**Economic and Social Council**Distr.: General
21 October 2016

Economic Commission for Europe**Inland Transport Committee****World Forum for Harmonization of Vehicle Regulations****Working Party on Passive Safety****Sixtieth session**

Regulation No. 16 (Safety-belts)**Proposal for Supplement 9 to the 06 series of Amendments to Regulation No. 16 (Safety belts) and Supplement 1 to the 07 series of Amendments****Submitted by the expert from France***

The text reproduced below was prepared by the expert from France, on behalf of the informal group on Child Restraints Systems and updates the latest versions of Regulation No. 16. The modifications to the current text of the UN Regulation and ECE/TRANS/WP.29/2016/98 are marked in bold for new or strikethrough for deleted characters.

Figure 7
Reduced-Size Rearward Facing toddler CRS Envelope dimensions for a reduced-size rearward-facing CRS, modified for improved compatibility with the vehicle interior

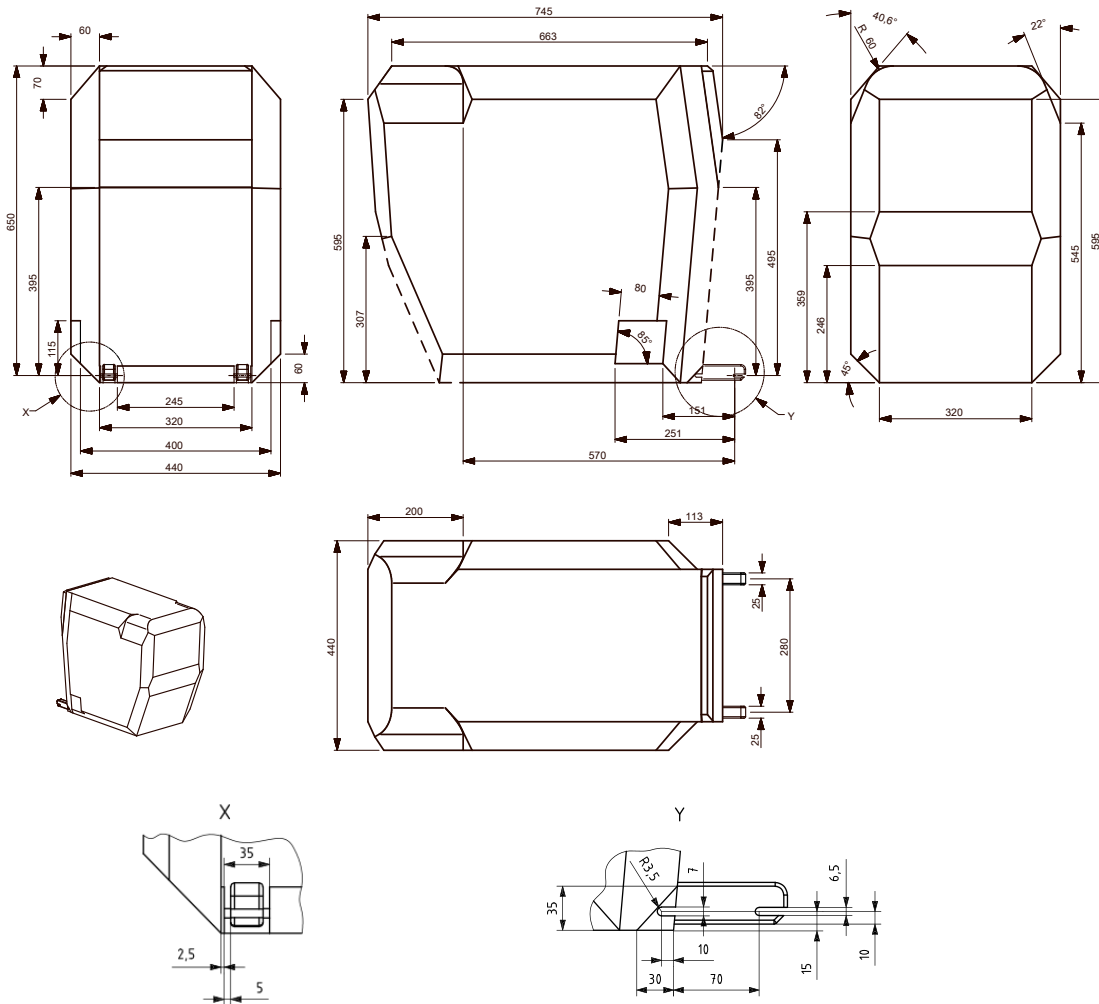
Annex 17, Appendix 2, insert new Paragraph 4.7.:

"4.7. Rearward facing infant child restraint systems envelope ISO/R2X

- 1 limits in the rearward and upward directions
- 2 dashed lines mark the area where an anti-rotation device, or similar (e.g. rebound bar), is allowed to protrude
- [3 the backward limitation (to the right in the figure) is given by the forward-facing envelope in Figure 2]
- 4 for further specifications of the connector area, see detail Y and ISO 13216-1:1999, Figures 2 and 3"

Figure 78
Envelope dimensions for lateral facing position CRS - ISO/L1- ~~ISOFIX SIZE CLASS F~~ or symmetrically opposite - ISO/L2 (figure shown) ~~ISOFIX CLASS G~~

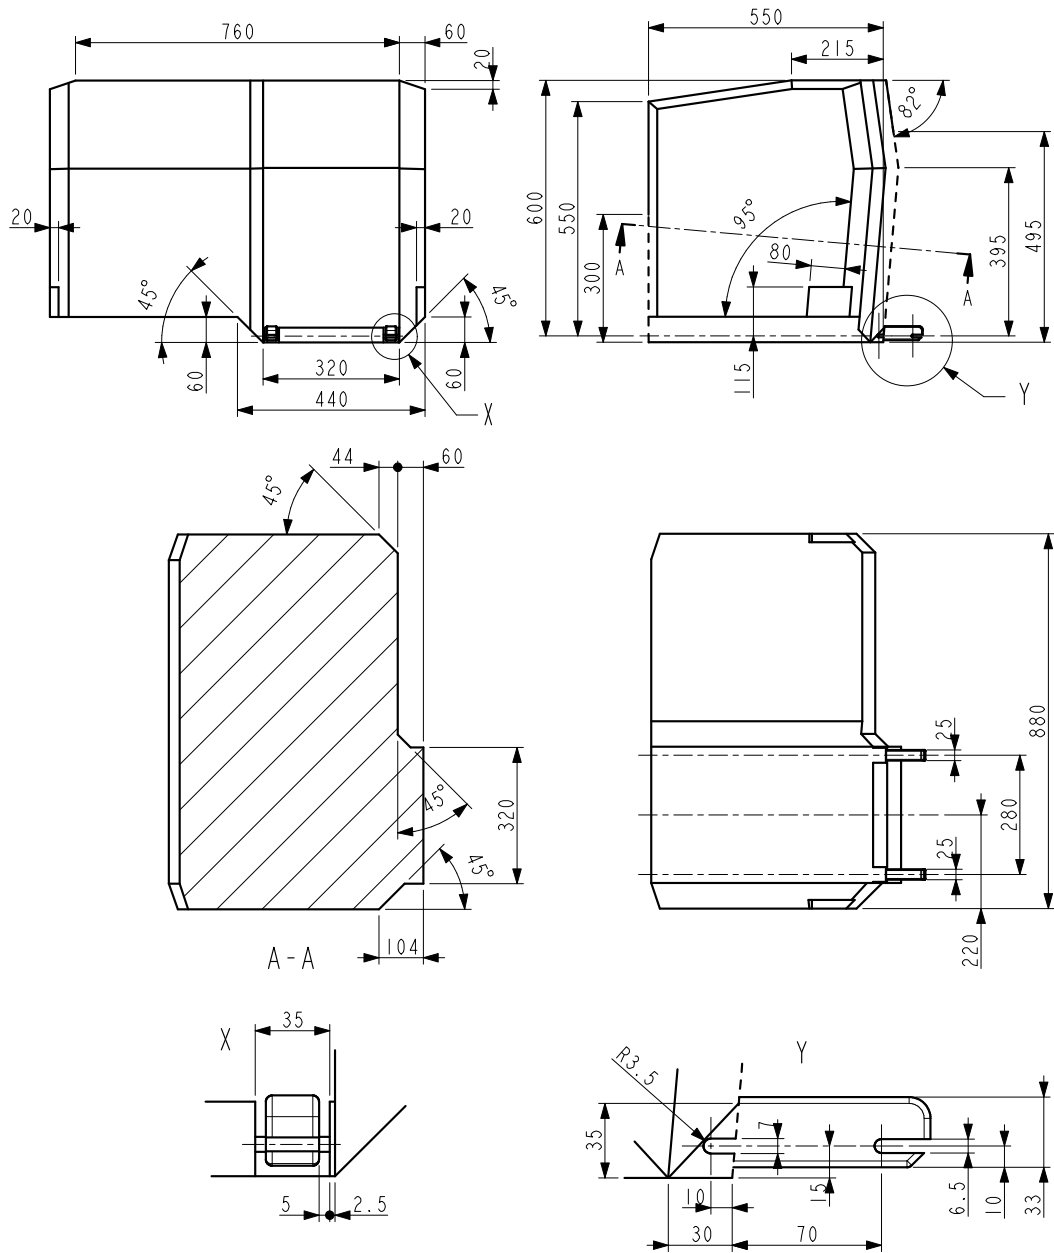
Annex 17, Appendix 2, paragraph 4.7.(former), renumber as para. 4.8. and amend to read:

"4.78. Lateral facing child restraint systems envelope

Note: The envelope for a left lateral-facing infant CRS (ISO/L1) has dimensions symmetric to ISO/L2 with regard to its intermediate longitudinal plan.

- 1** limits in the rearward and upward directions
- 2** dashed lines mark the area where an anti-rotation device, or similar (e.g. rebound bar), is allowed to protrude."

Figure 1
Positioning in seat

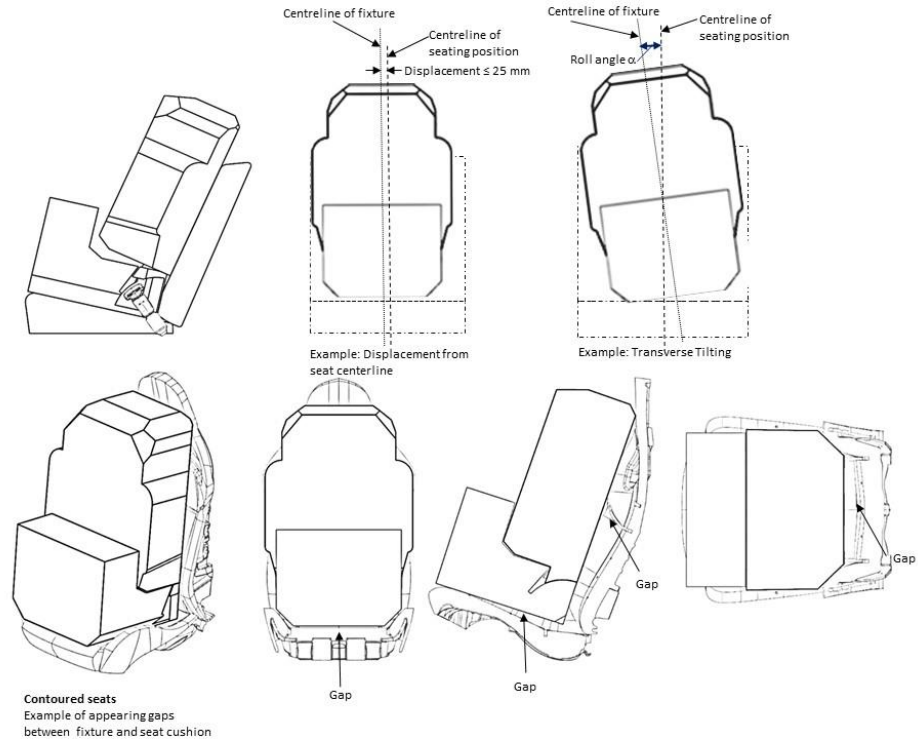
- 2.10. Ensure that the fixture is located with its centreline on the apparent centreline of the seating position ± 25 mm with its centreline parallel with the centreline of the vehicle seat. The roll angle α (see figure 1) shall be within $0^\circ \pm 5^\circ$

3. Requirements
 - 3.1. It shall be possible to secure the fixture in the seating position using the 3-point seat belt and to buckle up the seat belt.
 - 3.2. The roll angle α as shown in Figure 1 shall be equal to or less than 5° .

- 3.3. The base of the fixture shall be in contact with the seat cushion, and the back face of the fixture shall be in contact with the seat back or head restraint. Full contact with the seat is not necessary, "gaps" due to the vehicle seats contours are permitted as shown by the arrows in Figure 1. The booster seat envelope is equipped with an adjustable backrest. Compatibility with the vehicle seating position shall be achieved in at least one position of the backrest range shown in Figure 2 or Figure 3.

Figure 2
ISO/B2: Envelope dimensions for booster seat, reduced width 440 mm - without ISOFIX, or with connectors removed or stowed within the body of the fixture (behind line E, as defined by detail B).

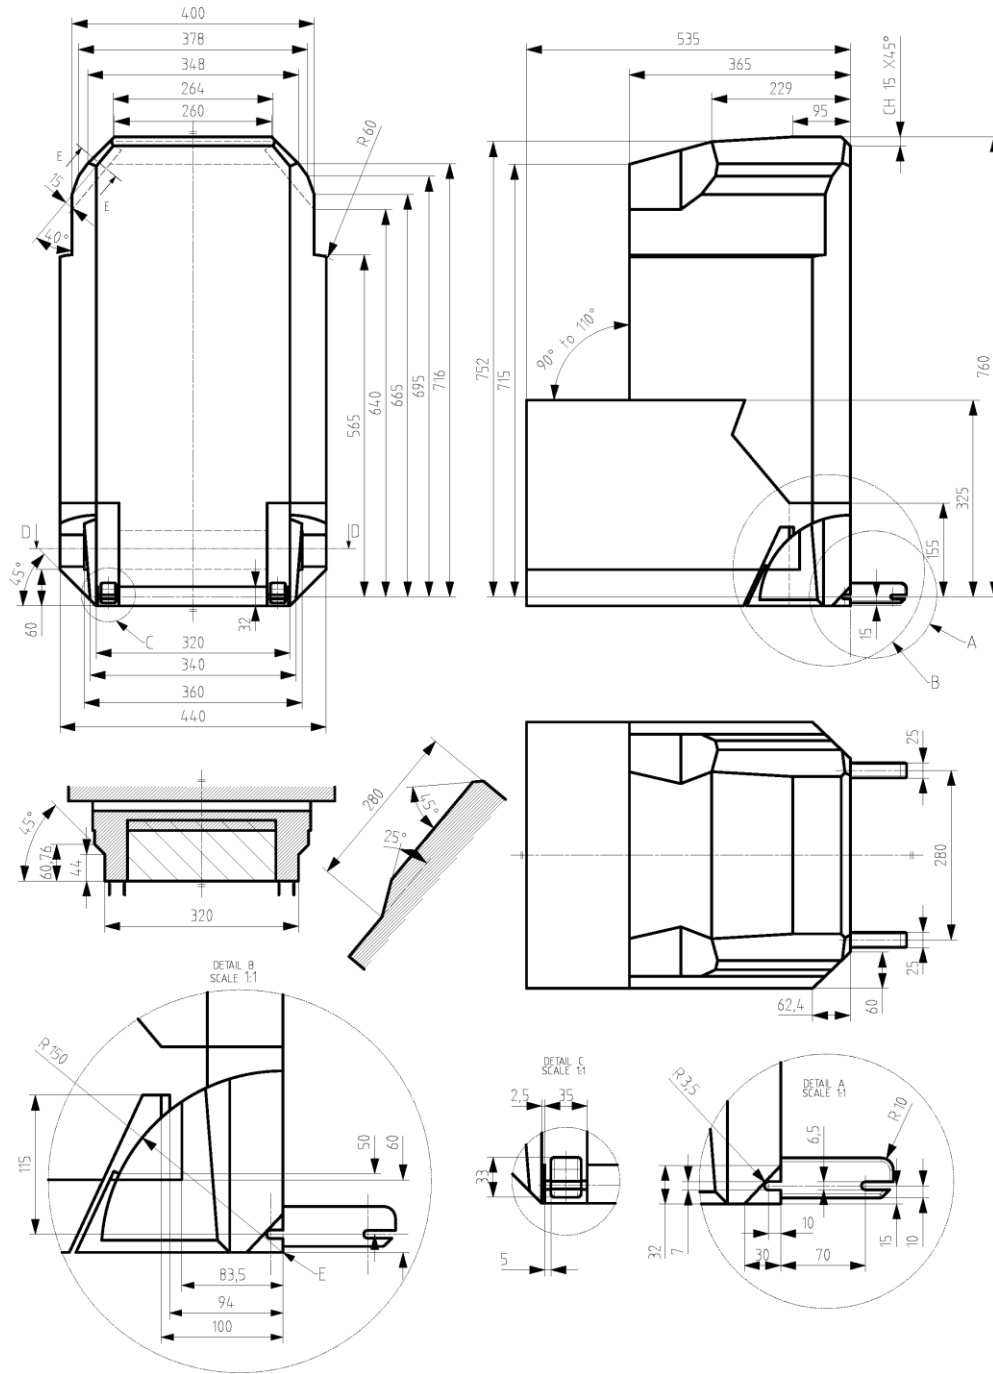
- 2.6. Place cotton cloths on the seat-back and cushion, if needed.
- 2.7. Remove the ISOFIX attachments from the CRF, or retract them to a position fully inside the backseat line (reference line E, Figure 2 or 3).

- 2.8. Place the fixture (as described in Figure 2 or 3 of this appendix) on the vehicle seat. The top of the fixture may touch the vehicle roof. Compression of the seat cushion is allowed to move the fixture into position.

4. Booster seat child restraint system fixtures:
 - (a) ISO/B2: Booster seat, reduced width 440 mm (figure 2)

Key E is the Reference axle of rotation of the backrest (90° to 110°) and reference line for retraction/stowing of ISOFIX

Figure 3
ISO/B3 - Envelope dimensions for booster seat, full width 520 mm - without ISOFIX,
or with connectors removed or stowed within the body of the fixture (behind line E, as
defined by detail B).

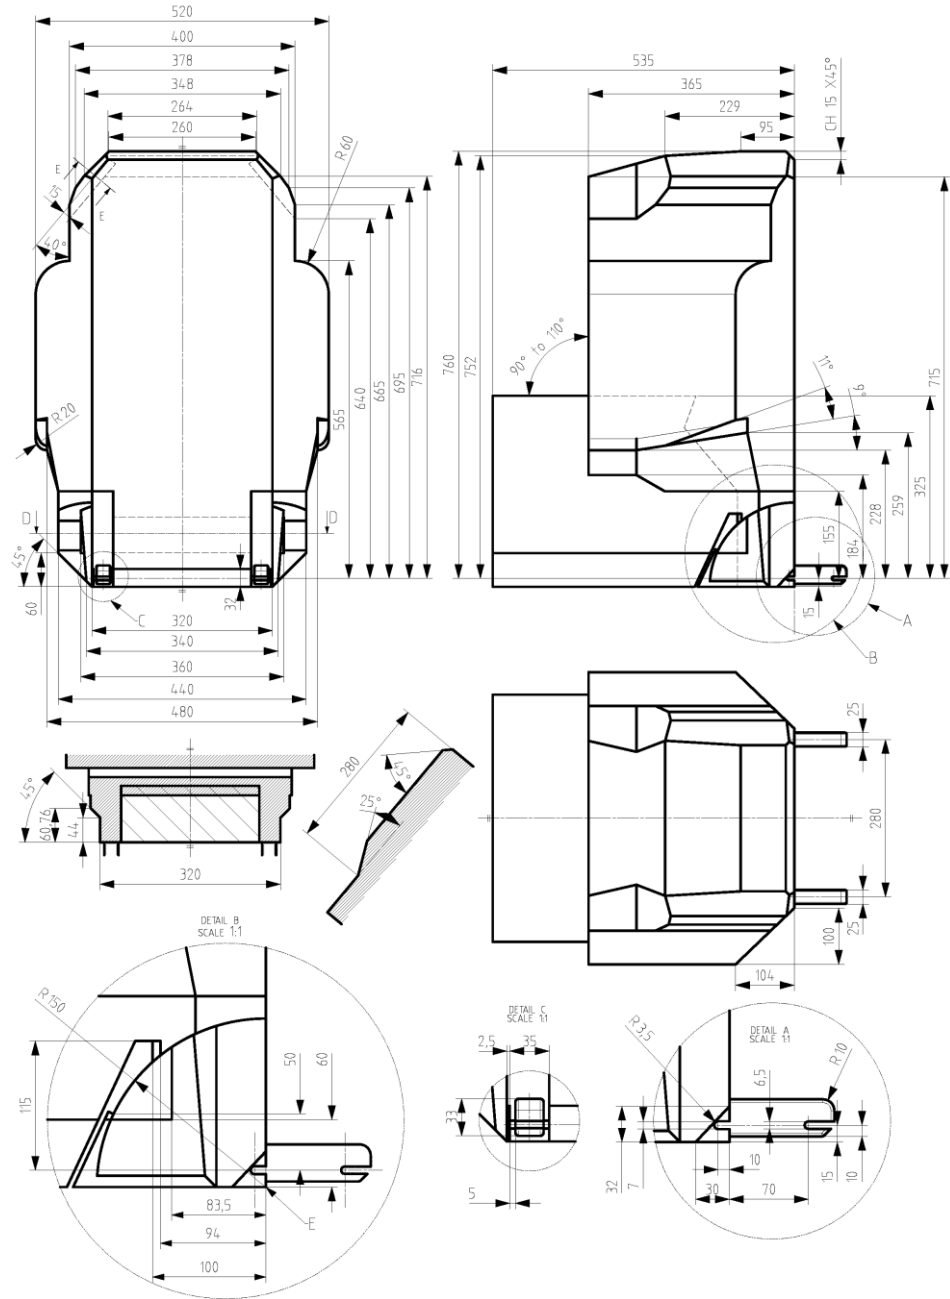
(b) ISO/B3: booster seat, full width 520 mm (figure 3)

Key **E** is the reference axle of rotation of the backrest (90° to 110°) and
reference line for retraction/stowing of ISOFIX
